Supplemental Draft EIS Errata

Table 2-1. Revisions to the Supplemental Draft EIS

FIGURE 4.1-2

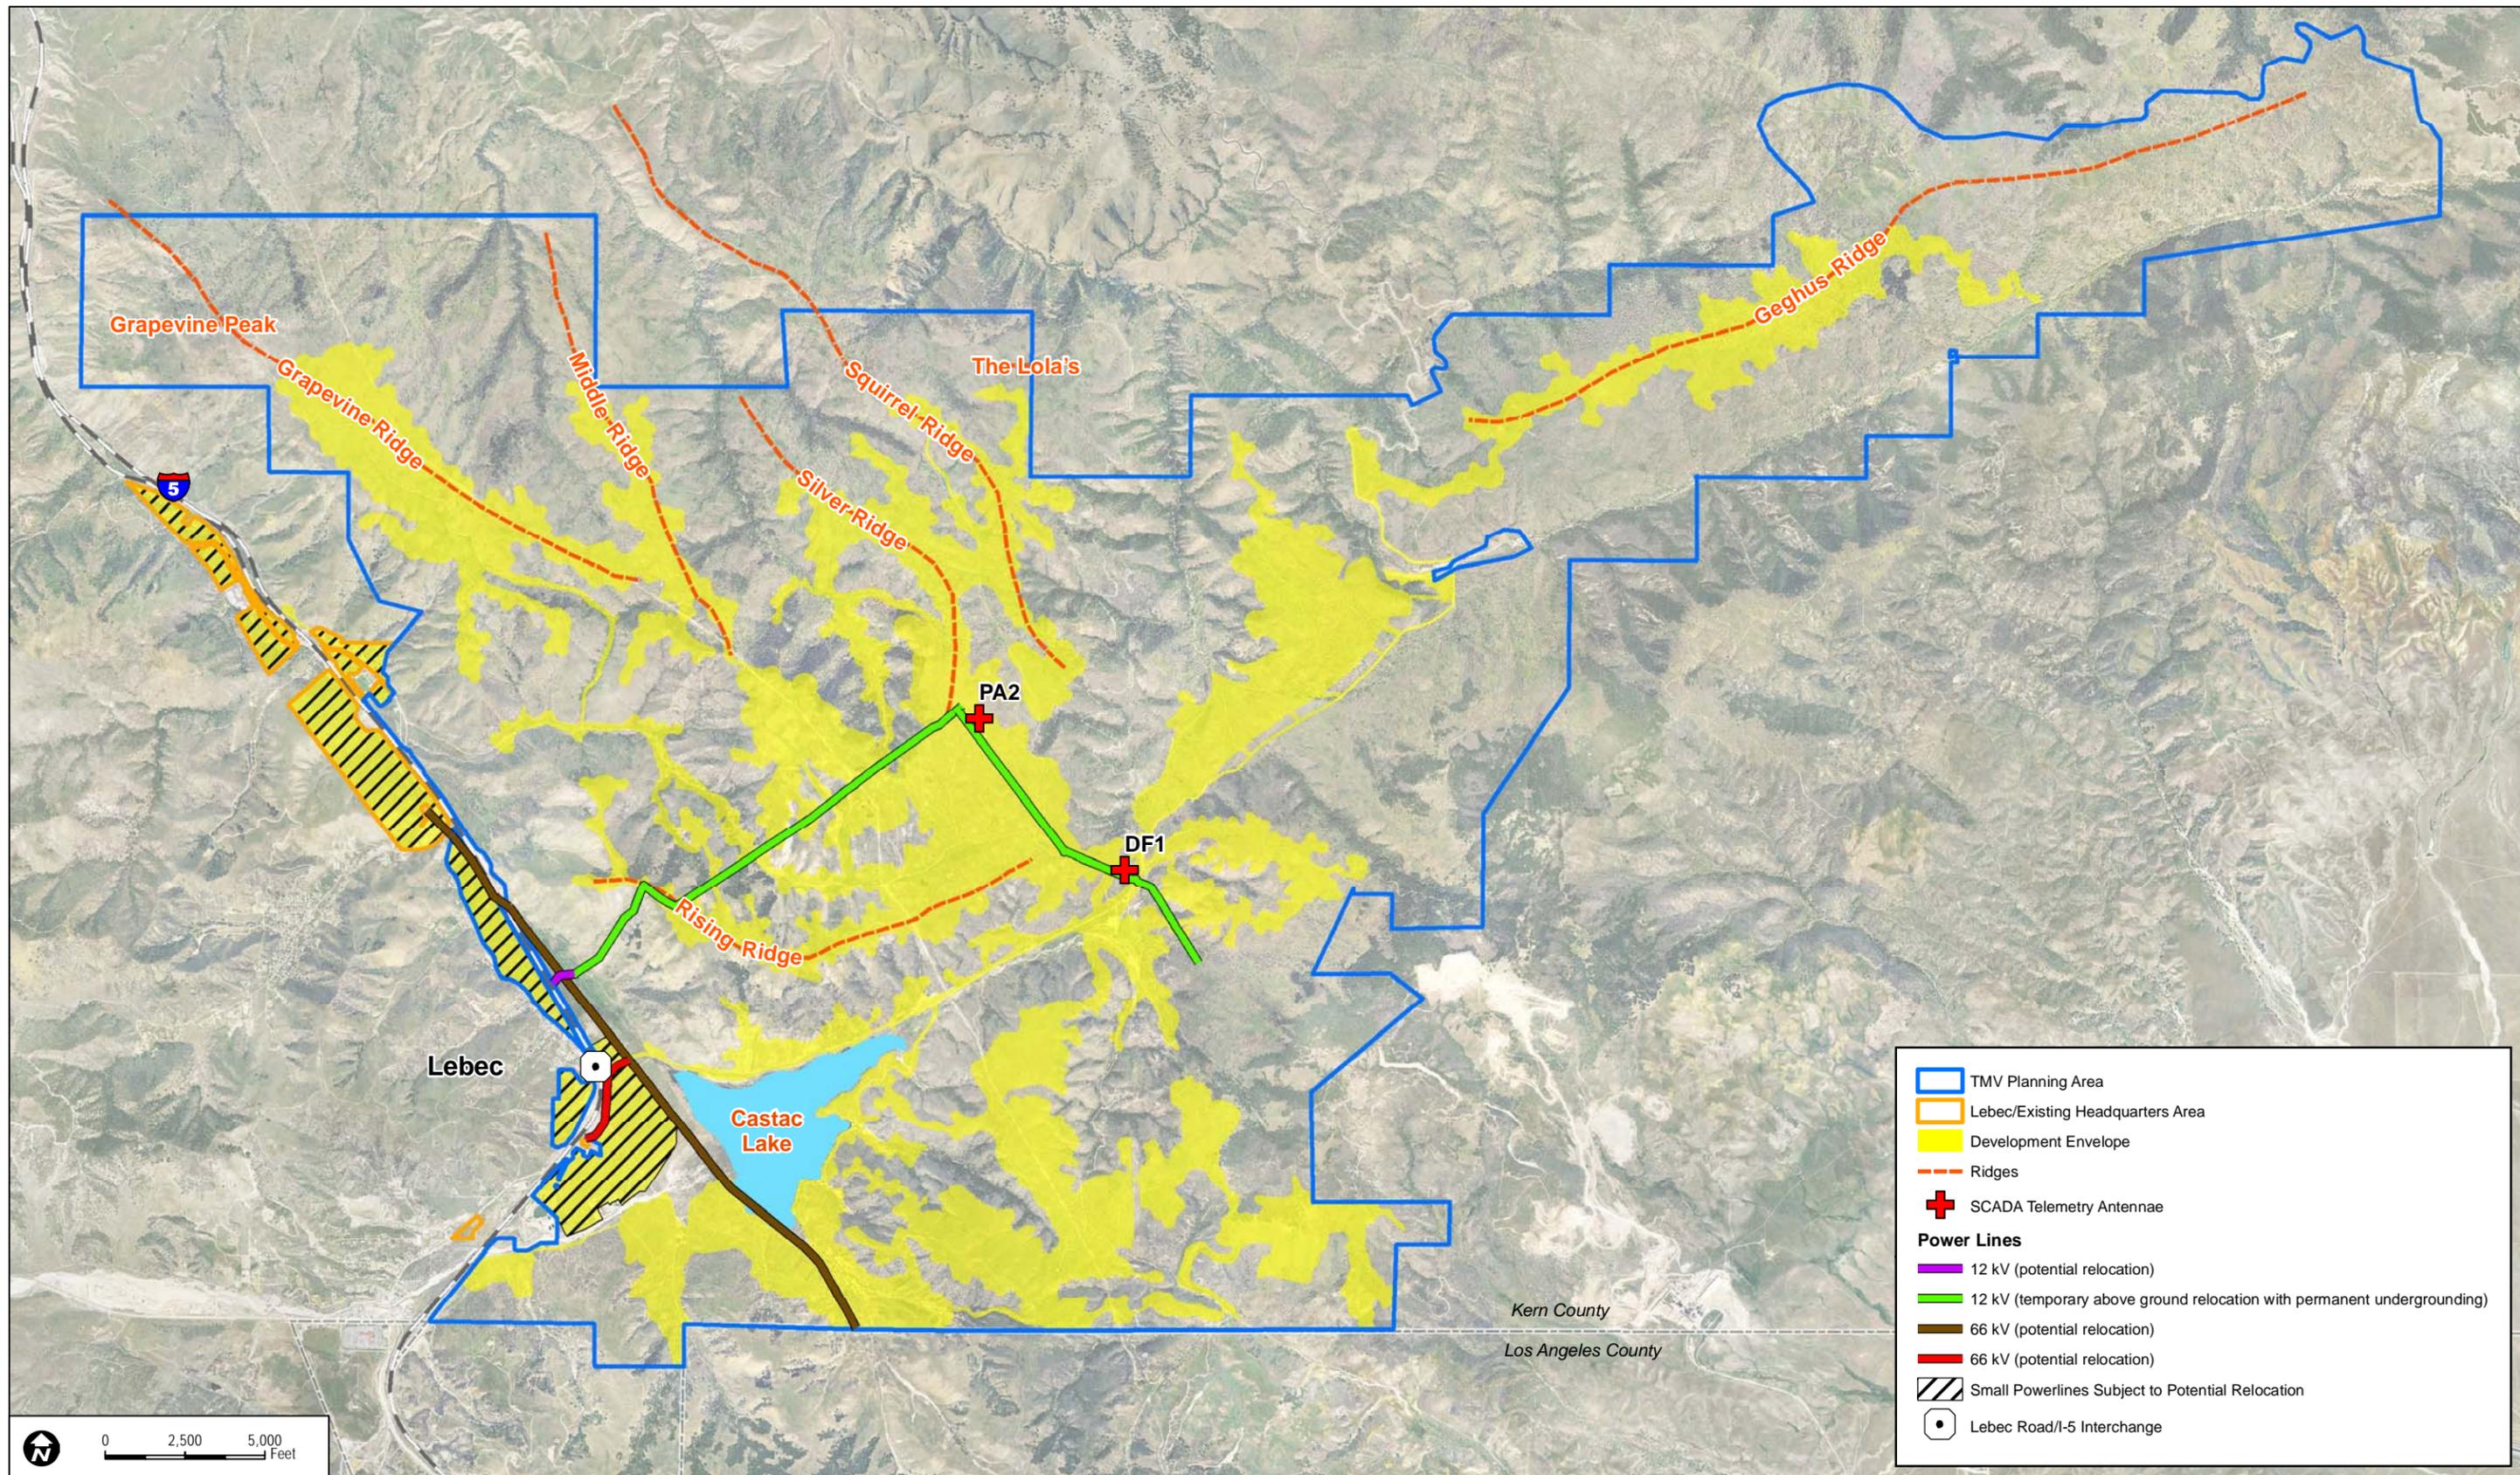
- the final location of the two emergency communications towers that would be located within the Tejon Mountain Village (TMV) Planning Area Development Envelope (see revised Figure 4.1-2 at the end of this Chapter);

4.1.3.2, page 4.1-26	Within the TMV Planning Area and Lebec/Existing Headquarters Area, the installation of two emergency communication towers (PA-2/DF-1) would be authorized under the Proposed TU MSHCP Alternative. These towers would be located at two separate locations in the TMV Planning Area Development Envelope to provide suitable emergency radio communication coverage (Figure 4.1-2). One of these towers would be approximately 68 78 feet in height (including antennae) and the other would be approximately 65 70 feet in height (including antennae). Both towers would be required to be self-supporting (i.e., no guide wires); and would incorporate Service-approved anti-perching devices on potential landing surfaces; and reflect a primarily solid tower façade to increase visibility for condors. For the PA-2 tower, TRC would consult with the Service regarding the feasibility of locating the tower downslope (closer to a group of large oak trees), and agrees to do so if Kern County determines the Service's proposed location would provide suitable emergency radio communications. Although there has been no documented take from collision with a tower or antennae by a condor, the risk of collision with the PA-2 tower would be further minimized if at final design and installation it can be located closer to a group of large oak trees. The placement and maintenance of any other future communication or utility tower to meet public safety requirements in the study area would be subject to review and approval by the Service, and would require amendment to the TU MSHCP or ITP and additional NEPA review if new, potentially significant effects are identified, including but not limited to impacts on or take of ESA-listed species.
